**Re: Bottle Rock Power Plant - 79-AFC- 4
Responses to Data Requests**

**PETITION TO AMEND FINAL DECISION TO RE-FIRE PLANT
BOTTLE ROCK POWER PLANT
79-AFC-4C**

RESPONSES TO CEC DATA REQUESTS

ATTACHMENT to RESPONSE #2

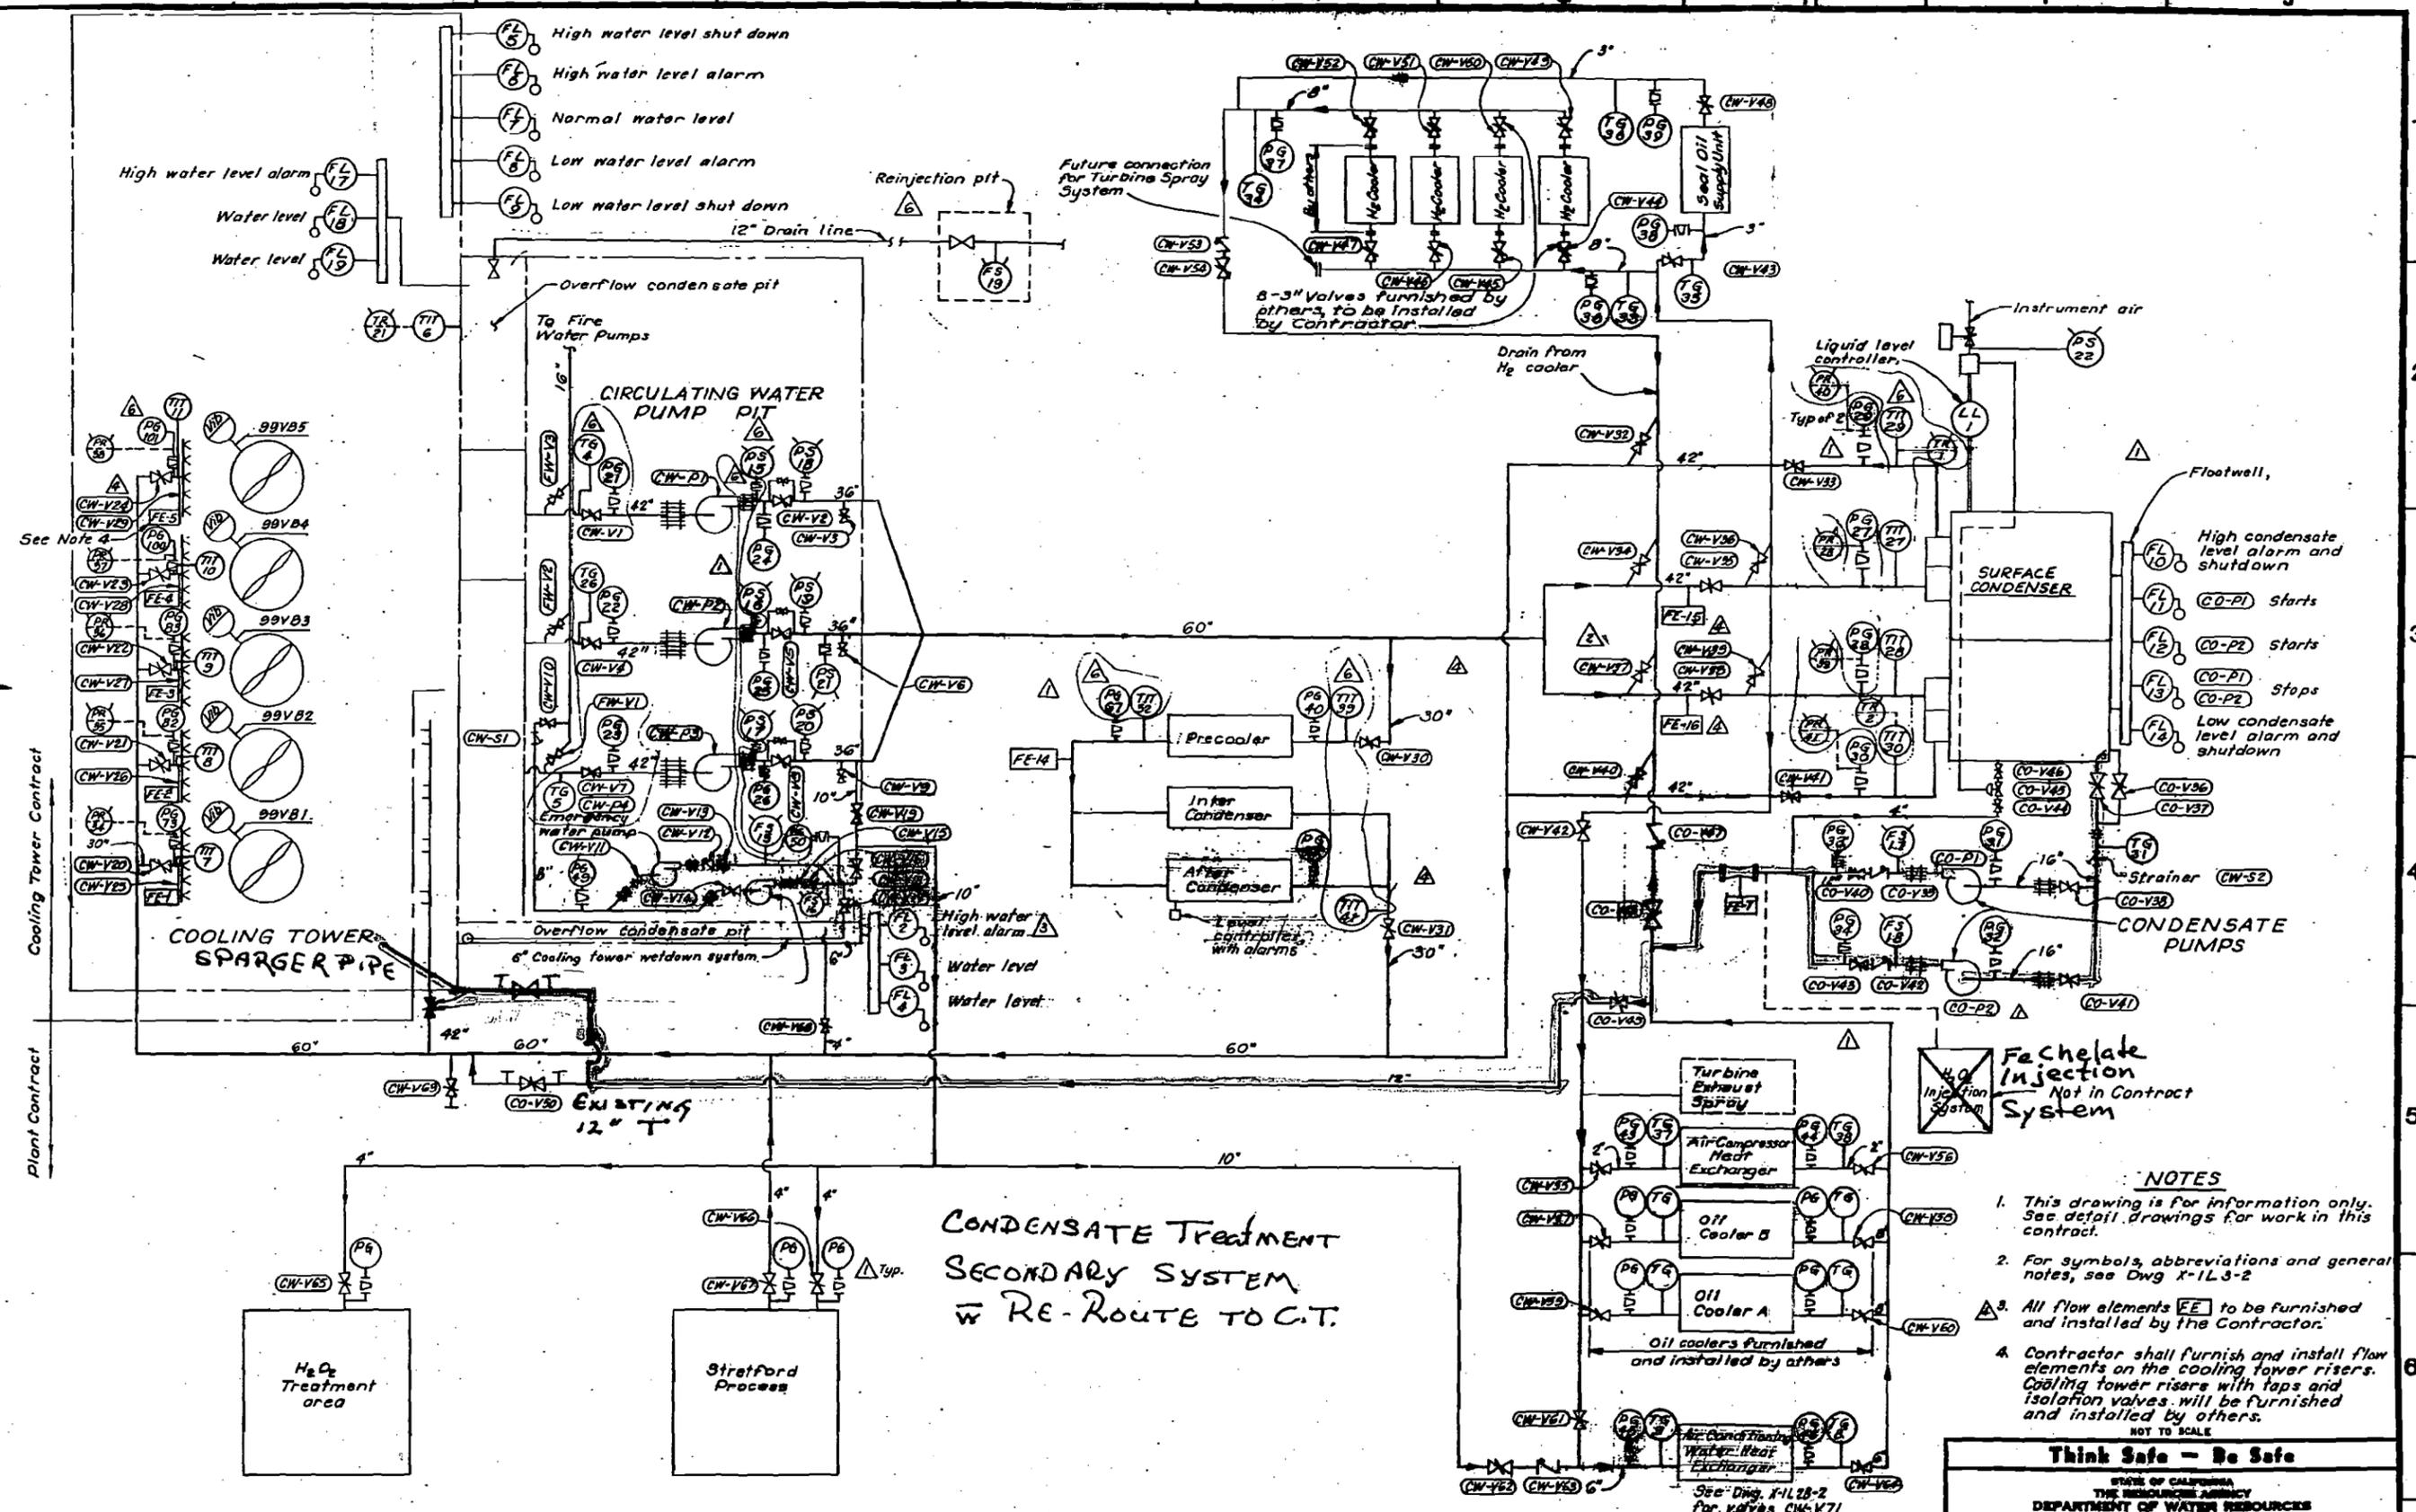
REQUEST #2: Please provide a BRPP site plan showing the location of the proposed hot condensate pipeline and the location of any other soil disturbing activities planned during plant refurbishment.

RESPONSE #2: Bottle Rock Power, LLC plans one (1) soil disturbing activity as part of refurbishing the Bottle Rock Power Plant for re-firing. The activity will provide the requisite trench for re-routing the hot condensate line so it can terminate in the cooling tower basin. This section of the hot condensate pipe must pass under the paved roadway that sets between the exiting concrete trench and the cooling tower.

The re-route pipeline is twelve inches in diameter. The applicable regulations mandate that the excavation must be at least twice the pipe diameter with respect to width and depth of the trench. Hence, the excavation will be approximately two feet wide by four feet deep by twenty feet long. The depth of four feet is necessary to accommodate the penetration of the existing hot condensate line through the existing concrete-lined trench. This new trench will yield approximately three cubic yards of excavated soil. See attached Drawing for pipeline and excavation perspective.
